UNITED STATES PATENT AND TRADEMARK OFFICE

09/747,052

Office Action Summary

DETAILED ACTION

Figure A

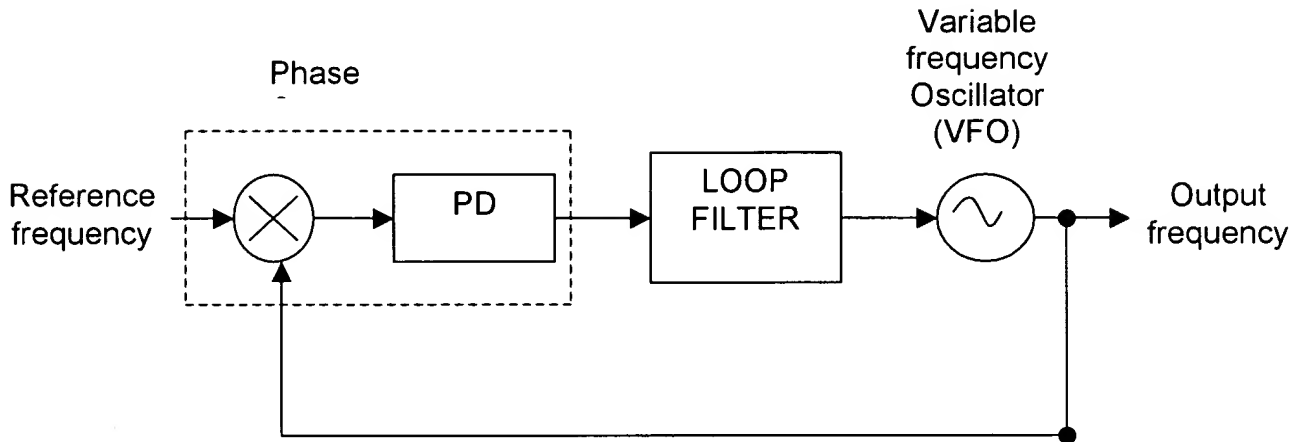
It is well known in the field of communication system that a PLL has the following structure (Fig.A).

The PLL circuit is arranged to have a phase comparator being inputted with a reference frequency, a low-pass filter (or Loop filter), and a variable frequency oscillator (VFO). The output from the VFO is taken as a PLL output signal (frequency) at an output terminal as well as sent back to the phase comparator 102. **The VFO normally uses a voltage controlled oscillator (VCO) for the analog PLL, while for the digital PLL, the VFO uses an oscillator arranged to change a frequency dividing ratio according to input phase error information, such as a number controlled oscillator (NCO).**

In operating, the phase comparator operates to compare the PLL output signal with the input signal. Then, the compared result (successive phase difference values) is sent to a Loop Filter through which a dc signal corresponding to the phase difference is taken out. Based on the phase difference signal, the oscillating frequency of the

VFO is controlled so that the resulting PLL output signal takes synchronization with the input reference signal.

In further, if the applicant does not agree that the NCO 9 output signal is not related to PLL generate output that is a basic PLL circuit structure, applicant should provide the technically detailed arguments to differentiate the instant application's PLL circuit theory to the basic PLL circuit theory provided in this argument.

Figure B

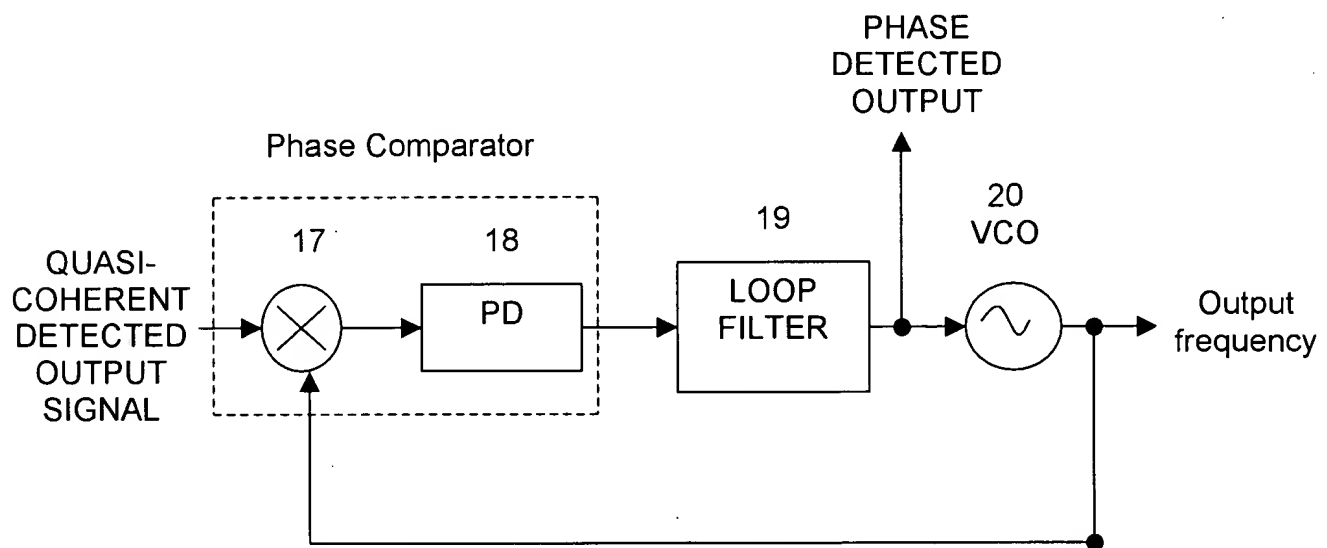
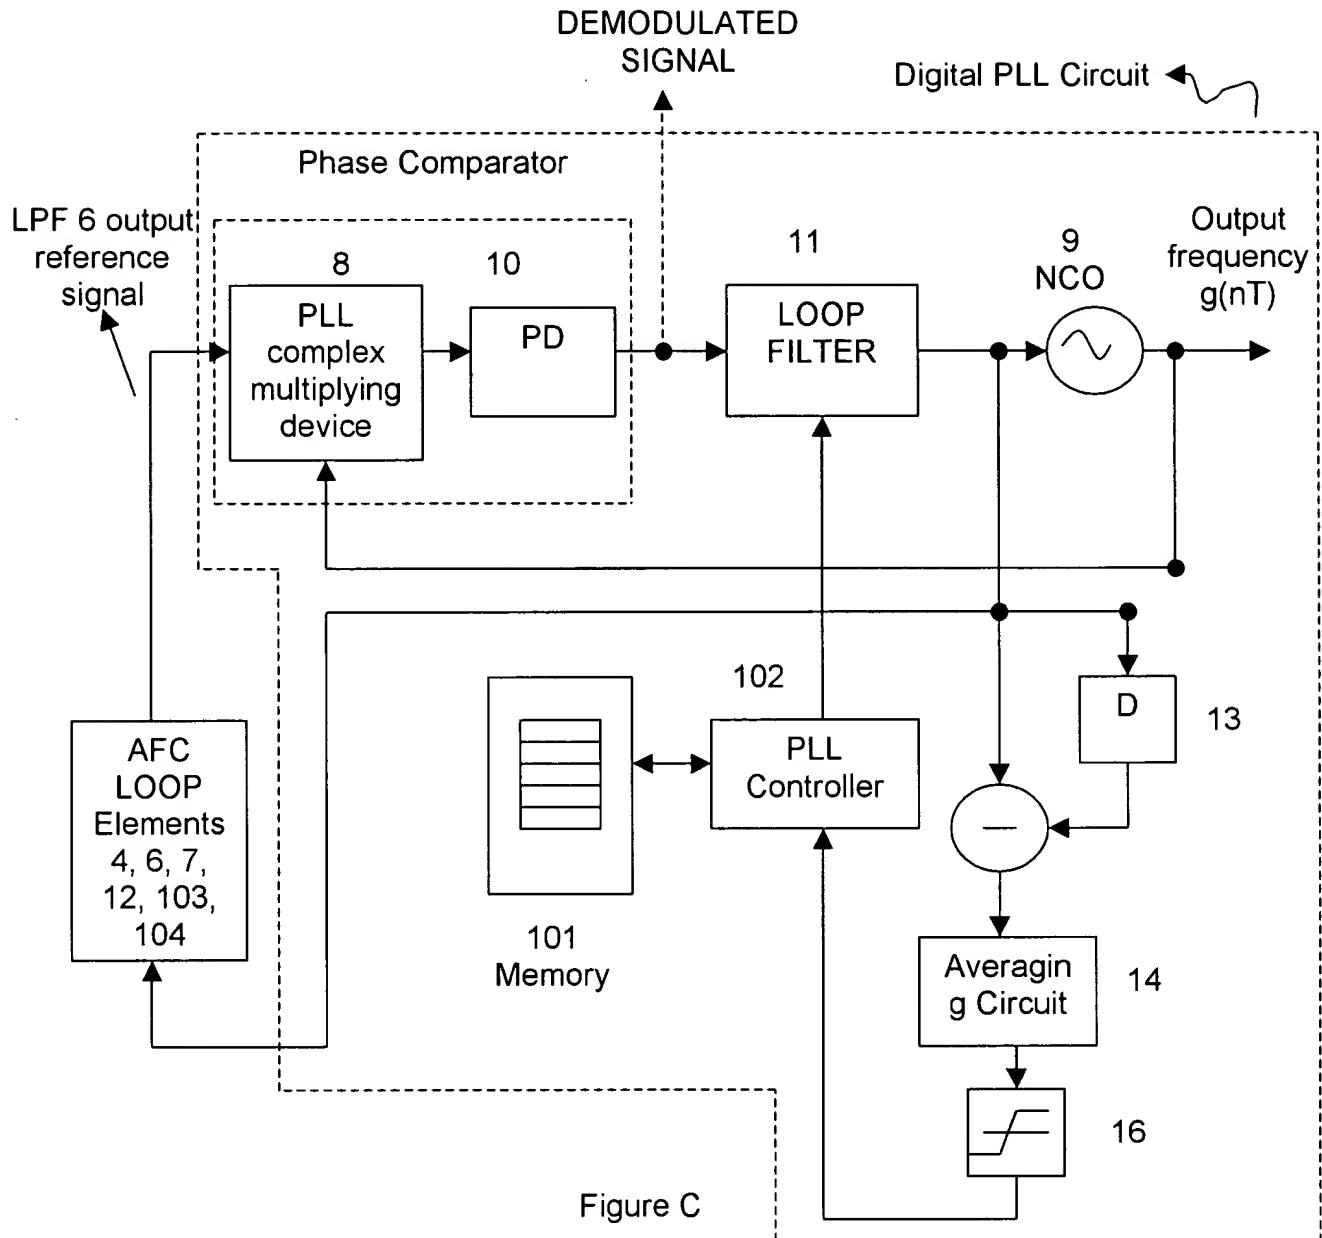
As shown in Fig.3, Tanaka teaches an analog PLL circuit (elements 17-20) with a voltage controlled oscillator (VCO) 20. Tanaka further teaches a digital PLL circuit (elements 8-11, 13-16, 101 and 102) with a numeric controlling oscillator (NCO) 26 in Fig.1. Fig.3 and Fig.1 of Tanaka's reference can be redrawn in the form of Fig.A basic PLL circuit block diagram as Figure B and Figure C, respectively. As we can easily seeing that both **Fig.3** and **Fig.1** of the PLL circuits have the exact same structure as that of **Figure A** as shown above. That is, the **Fig.3 (Fig.B)** of PLL circuit is an analog PLL with a VCO and **Fig.1 (Fig.C)** of PLL circuit is a digital PLL with a NCO.

The operation of Fig.3 (or Fig.B) analog PLL is described in column 1 line 25 – column 2 line 6 and the operation of Fig.1 (or Fig.C) digital PLL is described in column 3 line 58 – column 4 line 18, column 4 line 43 – column 5 line 14, and column 5 line 40 – column 6 line 24 of the Tanaka's reference.

Refer back to Fig.C, the NCO 9 output signal in not only with respect to NCO 9, but also with respect to the digital PLL.

Applicant also argued that the output of the (loop) filter 11 is proportional to the oscillation frequency of NCO 9, rather than being a function of successive control values within the meaning of Applicant's claims. In response this argument, examiner refers to Fig.1 (Figure C) of the Tanaka's reference again. The adjustable loop filter 11 output $g(nT)$ provides successive control values to the delayed element 13 and subtractor 14 and outputs a signal having a function of $\Delta g(nT)$, then the averaging circuit 15 averages the function of $\Delta g(nT)$ signal. The data determining device 16 compares the averaged signal with a threshold and outputs the determined signal to the PLL controller 102 to select the parameters of the loop range, the frequency control width, and the control time interval of the PLL corresponding to the output signal of the data determining unit 16 so as to control the PLL filter 11 (column 5 line 42 – column 6 line 6).

As admitted in the applicant's argument, the loop filter 11 is updated as a function of $\Delta g(nT)$ which is determined by a delaying device 13, a subtracting device 14, and an averaging circuit 15. Examiner cites column 5 equation 8 to show that the time change amount $\Delta g(nT)$ is a function of the successive phase difference values $g(nT)$ and a function of the delayed successive phase difference values $g(nT-T)$. i.e. $\Delta g(nT) = g(nT) - g(nT-T)$.

With this simple equation, it is inherent for one of ordinary skill in the art at the time of the invention was made should recognize $\Delta g(nT)$ is a function of the successive

phase difference values $g(nT)$ and the loop filter 11 is updated also as a function of average control value (output of averaging device 15) determined from the successive control value $g(nT)$.
